Access Compliance Report

Public Rights-of-Way

Intersection ID: 22520	Main Street: MAGNOLIA_BRIDGE_RD	Cross Street: RIESMAN_LN	Location: W
ADA ID: F398851429F6	Ramp Type: PerpDiag	Initial Pass/Fail: Fail	Overall Compliance: No
		Severity Score: 12.5

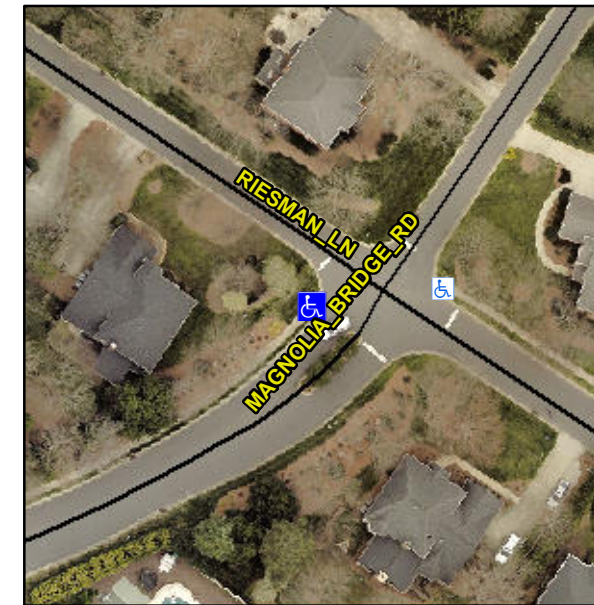
Not Found, R304.5.3

Compliance	Description	Data	Compliance	Description	Data
N/A	Ramp Length (in)	39.0	Yes	Ramp Slope (%)	5.1
Yes	Ramp Width (in)	48.0	No	Ramp XSlope (%)	6.1
N/A	Flare Type LT	N/A	N/A	Flare Type RT	N/A
N/A	Flare Slope LT (%)	N/A	N/A	Flare Slope RT (%)	N/A
N/A	Flare Traversable LT?	N/A	N/A	Flare Traversable RT?	N/A
N/A	Landing Length (in)	N/A	N/A	DWS Provided?	N/A
N/A	Landing Width (in)	N/A	N/A	DWS Contrast?	N/A
N/A	Landing Slope (%)	N/A	N/A	DWS Length (in)	N/A
N/A	Landing X Slope (%)	N/A	N/A	DWS Full Width?	N/A
N/A	Landing Curb? (Y/N)	N/A	N/A	DWS Offset (in)	N/A
N/A	Shared Landing?	N/A			
N/A	Gutter Ponding?	N/A	N/A	Gutter Slope (%)	N/A
N/A	Gutter Lip Ht (in)	N/A	N/A	Gutter X Slope (%)	N/A
N/A	Painted X Walk1?	No	N/A	Painted X Walk2?	No
	X Walk 1 Direction	To SE		X Walk 2 Direction	To NE
N/A	X Walk 1 Width (in)	N/A	N/A	X Walk 2 Width (in)	N/A
	X Walk 1 Slope (%)	1.2		X Walk 2 Slope (%)	3.9
	X Walk 1 X Slope (%)	4.3		X Walk 2 X Slope (%)	2.8

Remove & Replace Curb Ramp With Two New Directional Ramps or Equivalent.
